Access Compliance Report

Public Rights-of-Way

(Curb Ramps)

Intersection ID: 3556	Main Street: PROSPERITY_CHURCH_RD	Cross Street: WHITE_CASCADE_DR	Location: W
ADA ID: 89B90CBD6447	Ramp Type: Perp	Initial Pass/Fail: Fail	Overall Compliance: No
Severity Score: 22.5			
Codes/Mitigation Info/Possible Solution		Field Measurements/Component Compliance

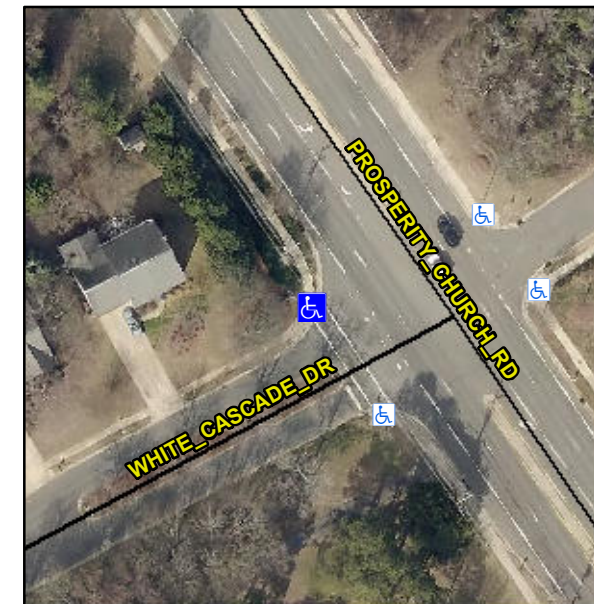
R304.5.1, R304.2.2, R304.5.3

Compliance	Description	Data	Compliance	Description	Data
N/A	Ramp Length (in)	72.0	No	Ramp Slope (%)	9.2
No	Ramp Width (in)	37.0	No	Ramp XSlope (%)	3.5
N/A	Flare Type LT	N/A	N/A	Flare Type RT	N/A
N/A	Flare Slope LT (%)	N/A	N/A	Flare Slope RT (%)	N/A
N/A	Flare Traversable LT?	N/A	N/A	Flare Traversable RT?	N/A
N/A	Landing Length (in)	N/A	N/A	DWS Provided?	N/A
N/A	Landing Width (in)	N/A	N/A	DWS Contrast?	N/A
N/A	Landing Slope (%)	N/A	N/A	DWS Length (in)	N/A
N/A	Landing X Slope (%)	N/A	N/A	DWS Full Width?	N/A
N/A	Landing Curb? (Y/N)	N/A	N/A	DWS Offset (in)	N/A
N/A	Shared Landing?	N/A			
N/A	Gutter Ponding?	N/A	N/A	Gutter Slope (%)	N/A
N/A	Gutter Lip Ht (in)	N/A	N/A	Gutter X Slope (%)	N/A
N/A	Painted X Walk1?	Yes	N/A	Painted X Walk2?	N/A
	X Walk 1 Direction	To SE		X Walk 2 Direction	N/A
N/A	X Walk 1 Width (in)	98.0	N/A	X Walk 2 Width (in)	N/A
	X Walk 1 Slope (%)	0.9		X Walk 2 Slope (%)	N/A
	X Walk 1 X Slope (%)	3.7		X Walk 2 X Slope (%)	N/A

Remove & Replace Entire Ramp.
